**STATE OF CONNECTICUT
CONNECTICUT SITING COUNCIL**

IN RE: :
 :
 : DOCKET NO. 510
 :
 NEW CINGULAR WIRELESS PCS, LLC :
 D/B/A AT&T AND TARPON TOWERS II, :
 LLC APPLICATION FOR A CERTIFICATE :
 OF ENVIRONMENTAL COMPATIBILITY :
 AND PUBLIC NEED FOR THE :
 CONSTRUCTION, MAINTENANCE AND :
 OPERATION OF A :
 TELECOMMUNICATIONS FACILITY : August 1, 2022
 LOCATED AT 92 GREENS FARMS ROAD,
 WESTPORT, CONNECTICUT

**NEW CINGULAR WIRELESS PCS, LLC D/B/A AT&T AND TARPON
TOWERS II, LLC RESPONSES TO CONNECTICUT SITING COUNCIL
PRE-HEARING INTERROGATORIES DATED JULY 8, 2022**

Existing Coverage
1900 MHz LTE

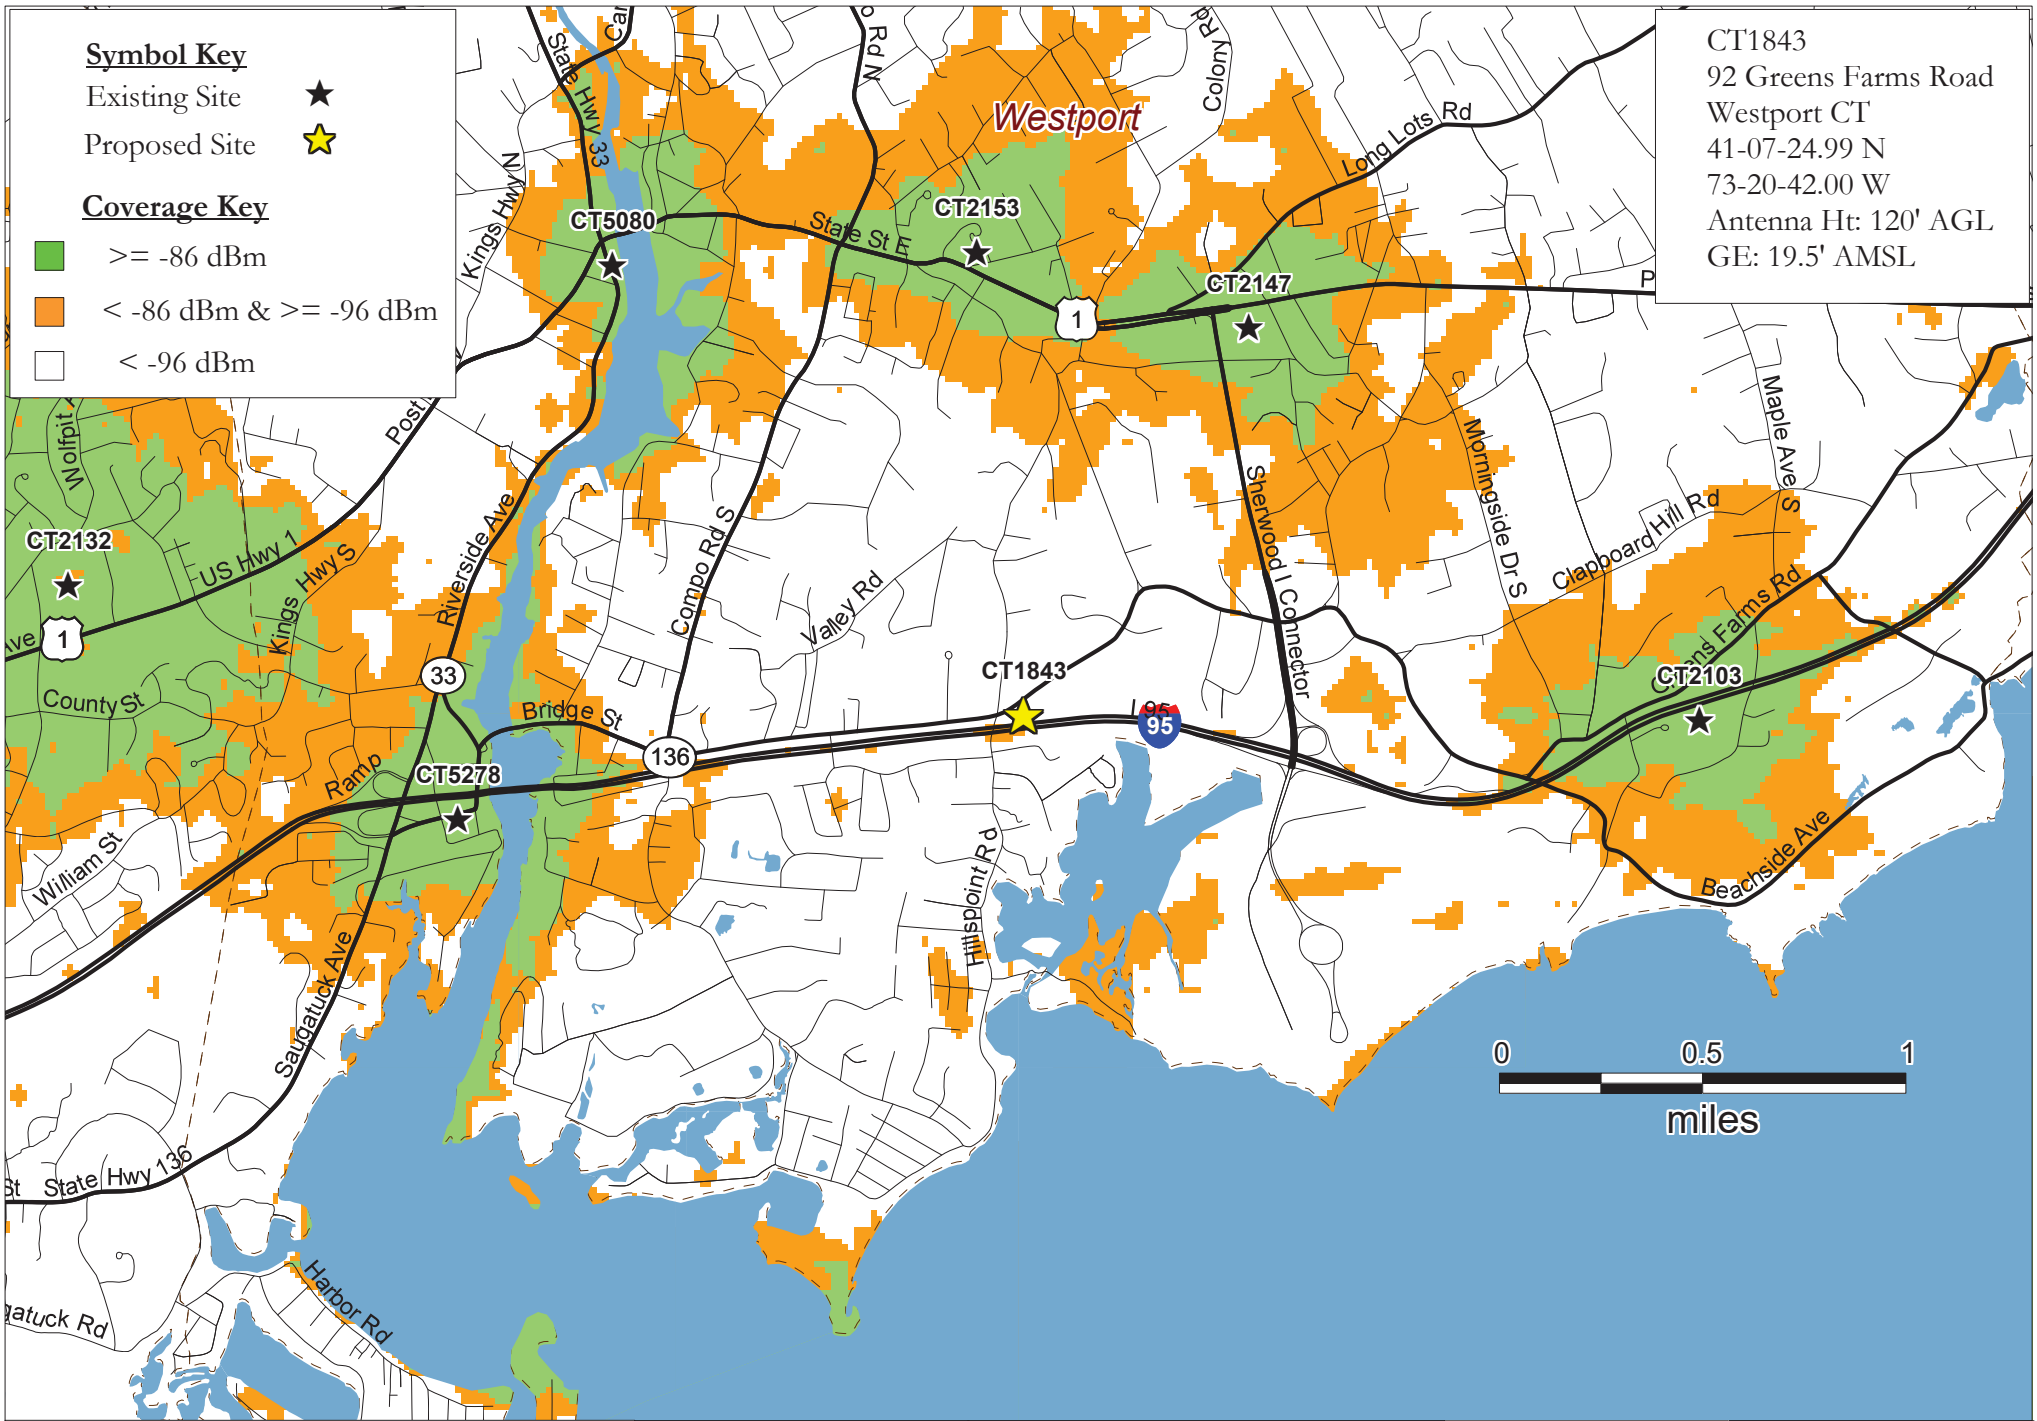
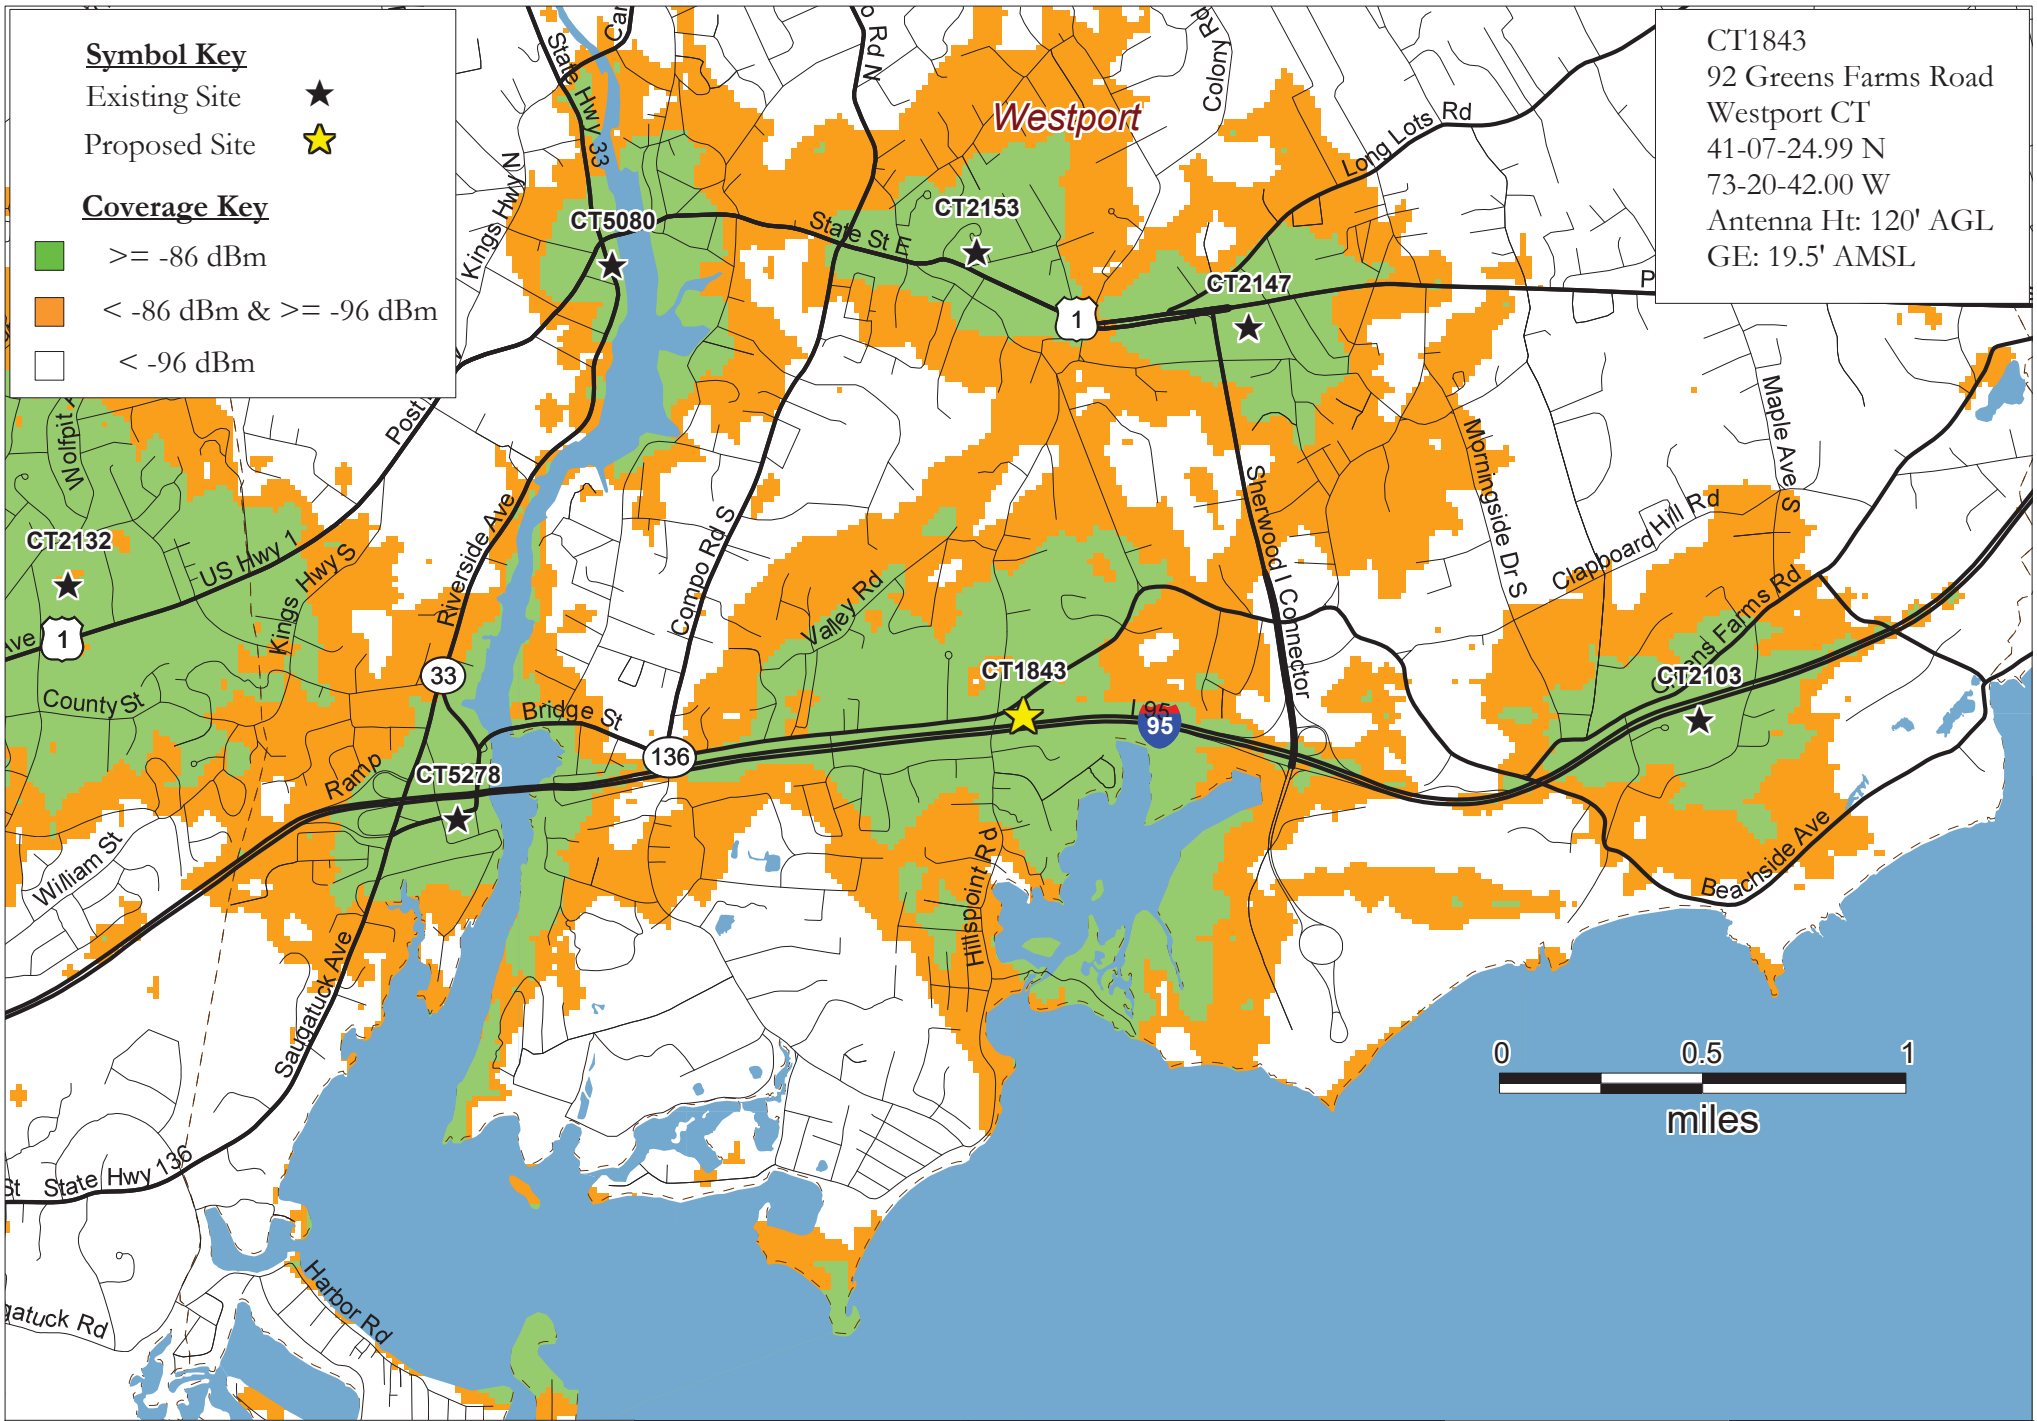
28. Provide coverage models for existing and proposed 1900 MHz, 2100 MHz and 3500 MHz services.

Please see plots included in Exhibit 28 attached hereto.

Please see the coverage plots included in Exhibit 28. The predicted coverage footprints are as follows:
